Project	<b>IEEE 802.16 Broadband Wireless Access Working Group</b> < <a href="http://ieee802.org/16">http://ieee802.org/16</a> >		
Title	AK validation after MS handover when CIDs are pre-allocated		
Date Submitted	<b>2008-01-14</b>		
Source(s)	Shashikant Maheshwari, Yousuf Saifullah, Haihong Zheng, Giovanni Maggi, Aik Chindapol Nokia Siemens Networks	Voice: E-mail:	shashikant.maheshwari@nsn.com * <a href="http://standards.ieee.org/faqs/affiliationFAQ.html">http://standards.ieee.org/faqs/affiliationFAQ.html</a> >
Re:	In response to LB26		
Abstract	This contribution proposed bandwidth efficient AK validation after MS handover to Target-BS when CIDs are pre-allocated to reduce HO interruption time.		
Purpose	Accept the proposed specification changes on IEEE P802.16Rev2/D1.		
Notice	<i>This document does not represent the agreed views of the IEEE 802.16 Working Group or any of its subgroups. It represents only the views of the participants listed in the "Source(s)" field above. It is offered as a basis for discussion. It is not binding on the contributor(s), who reserve(s) the right to add, amend or withdraw material contained herein.</i>

## AK validation after MS handover when CIDs a

Figure xxx: AK Validation after Handover at T-BS

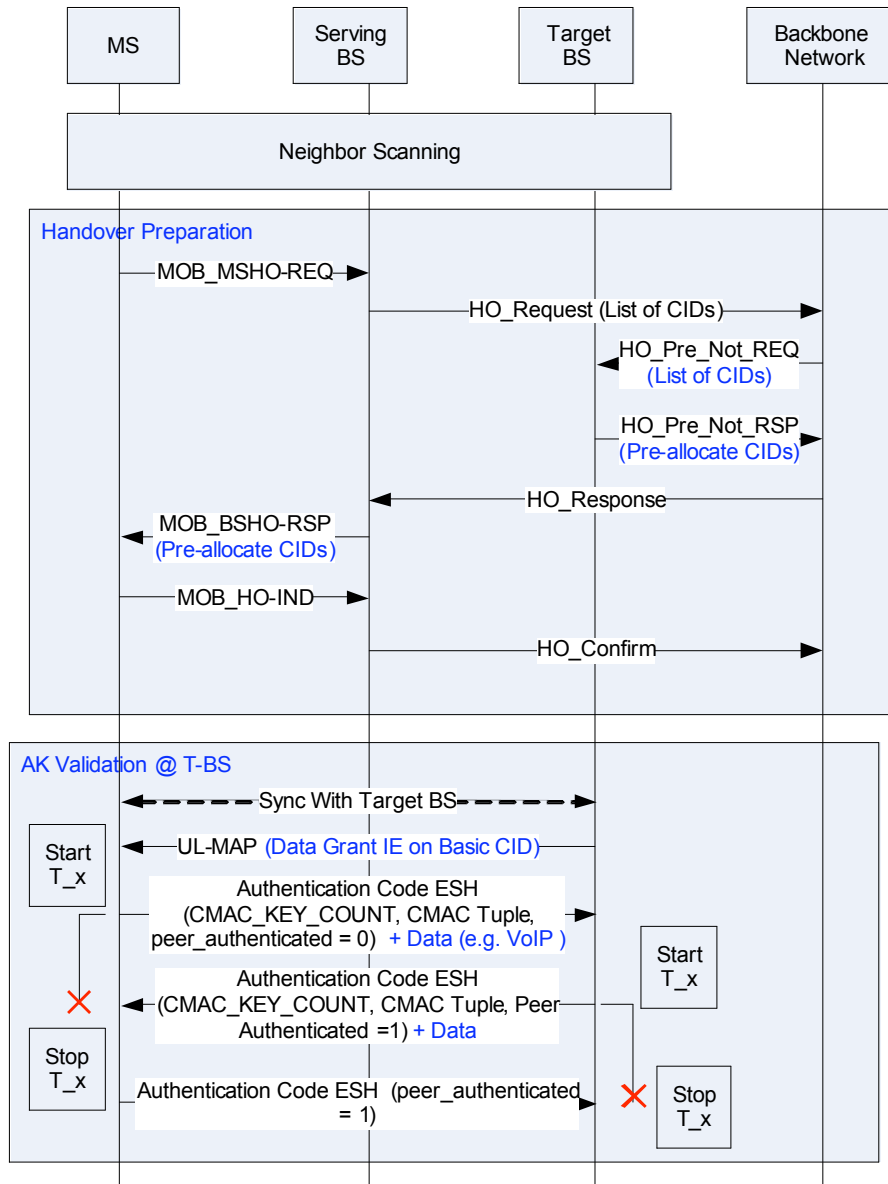
*[Insert the following para on Page xxx line xxx as shown below]*

Authentication Code ESH may be sent along with the Data. Similar AK validation operation is performed by BS on the DL. Figure xxx illustrates the AK validation procedure initiated by the MS after switching to T-BS. Timer T58 is defined to wait for the peer entity to be validated. If Timer T58 at MS is expired then MS shall perform contention based ranging and if Timer T58 at BS is expired then BS shall abandon the MS network re-entry.
